CITY PLANNING COMMISSION

APPLICATION: A. Plan Review of 19,977+ square foot automobile sales and service buildings on 3.92+ vacant acres in the General Commercial Review-Executive Airport-4({C-2-R}{EA-4}) zone.

PROPOSAL: The applicant is requesting the necessary entitlements to construct a new car dealership with auto storage, service and display areas.

APPLC. NO. P87-372 MEETING DATE October 8, 1987 ITEM NO 10

ELEVATIONS

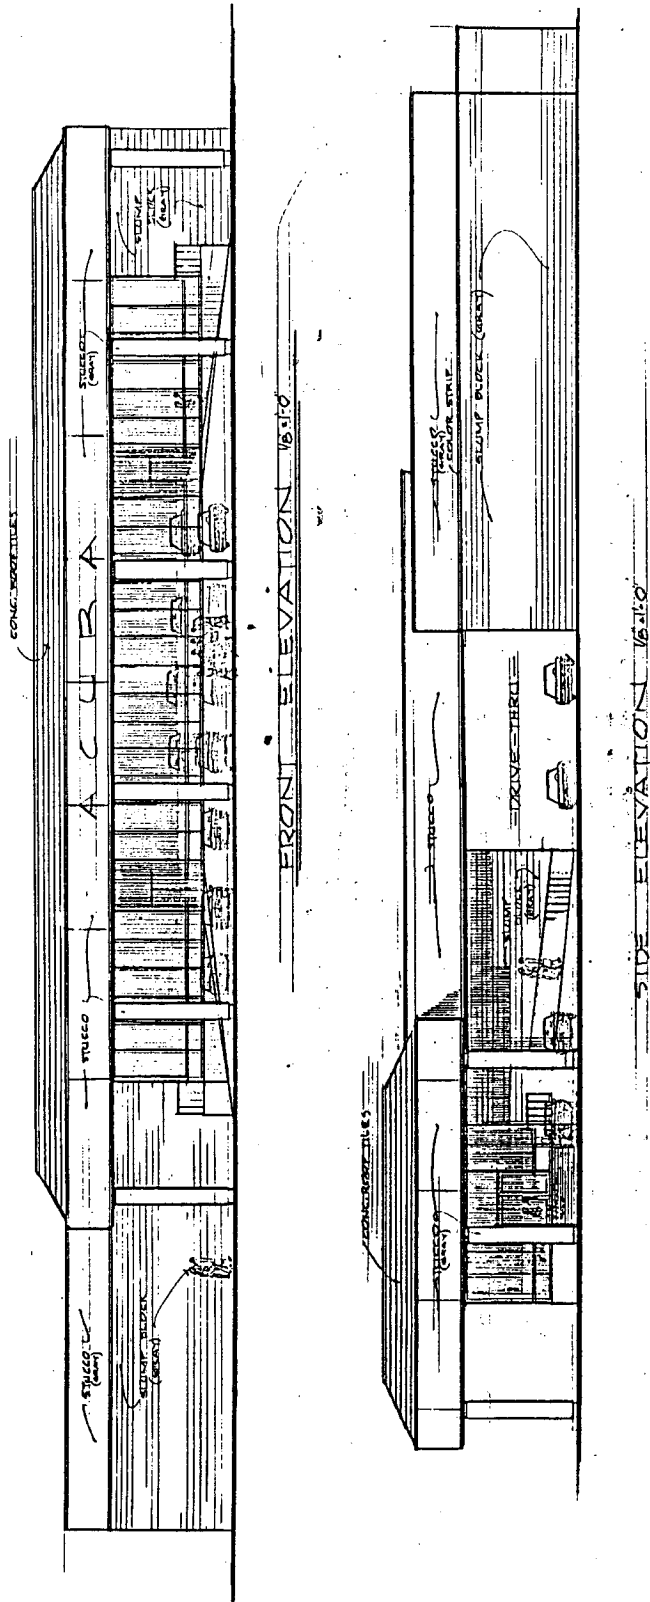
- a. The exterior elevations provide a horizontal architectural appearance. Staff has a concern over the relative monotonous style of the east building elevations. In order to provide more relief, staff recommends the addition of several landscape planters adjacent to the building as shown on Exhibit D as noted.

Along the east-facing walls staff suggests planting of vertical climbing vines or shrubbery which break-up the horizontal style of the building wall. Such a modification can be shown on the revised site and landscape plans.

- a. the addition of landscape planter boxes adjacent to the east wall elevations as shown on Exhibit D as Note 5;
 - b. trees be located adjacent to the public right-of way every 30 feet as a minimum and be a minimum of 15 gallon container size;

EXHIBIT D

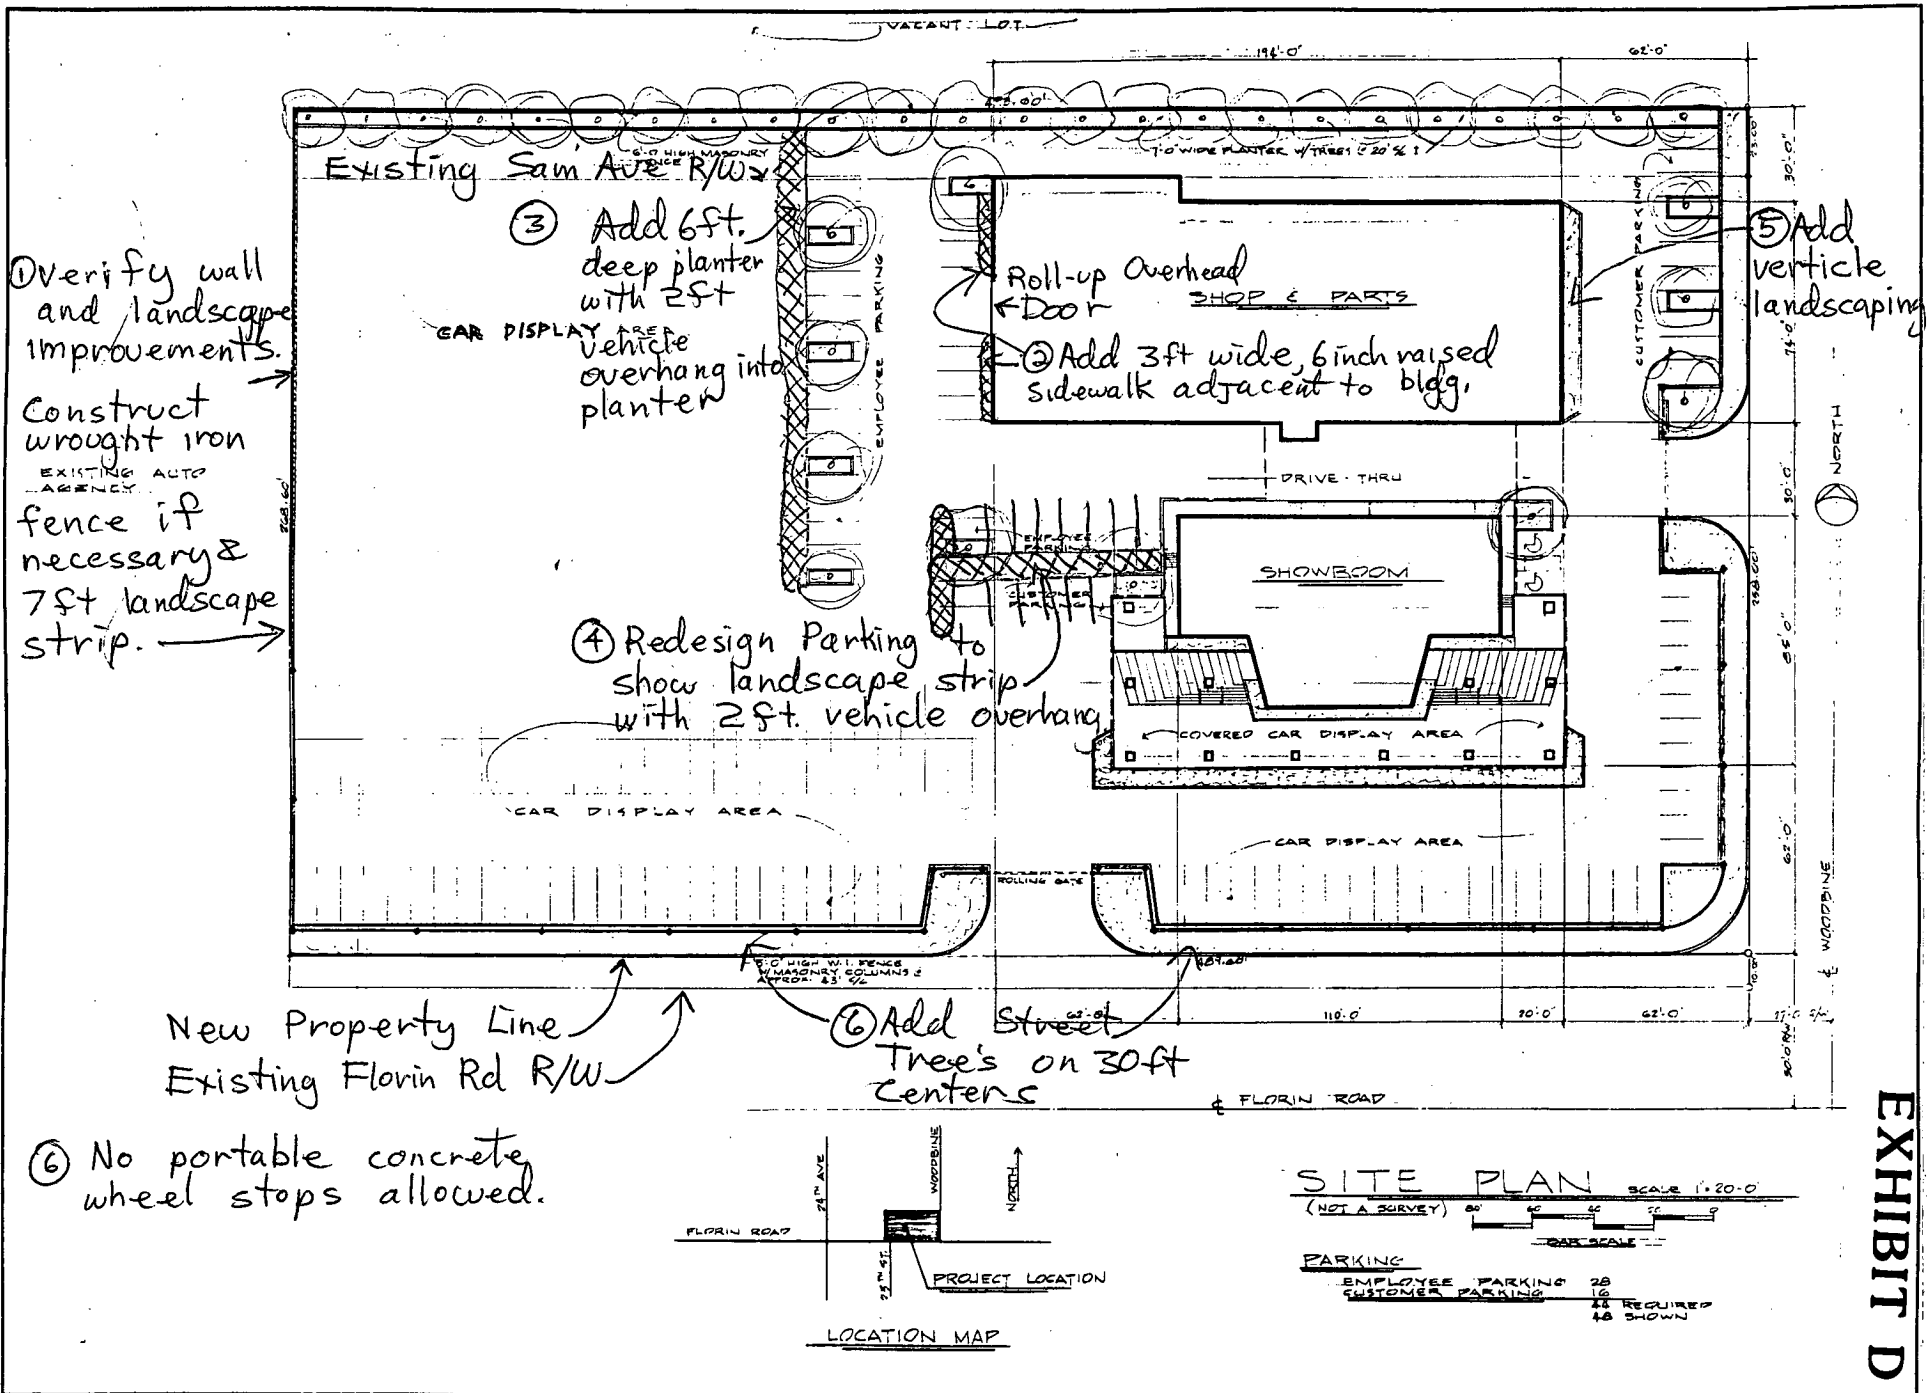
1 Verify wall and landscape improvements. Construct wrought iron fence if necessary & 7ft landscape strip.

2 Add 6ft deep planter with 2ft vehicle overhang into planter

3 Add 3ft wide, 6 inch raised sidewalk adjacent to bldg.

4 Redesign Parking to show landscape strip with 2ft vehicle overhang

5 Add verticle landscaping

6 Add Street Tree's on 30ft Centers

7 No portable concrete wheel stops allowed.
